Access Compliance Report

Public Rights-of-Way

(Curb Ramps)

Intersection ID: 14333	Main Street: BARRINGER_DR	Cross Street: BEECH_NUT_RD	Location: NW
ADA ID: 53E36B4F39CC	Ramp Type: BlendTrans2	Initial Pass/Fail: Pass	Overall Compliance: No
		Severity Score: 2.5

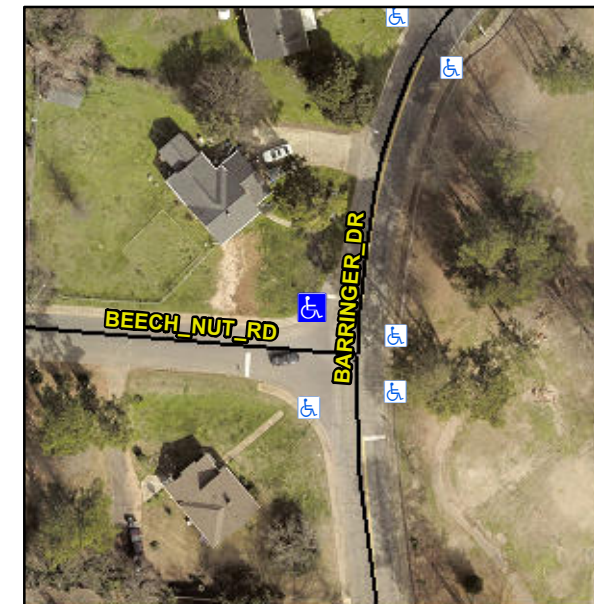
Remove & Replace Detectable Warning System.

R305.1.4
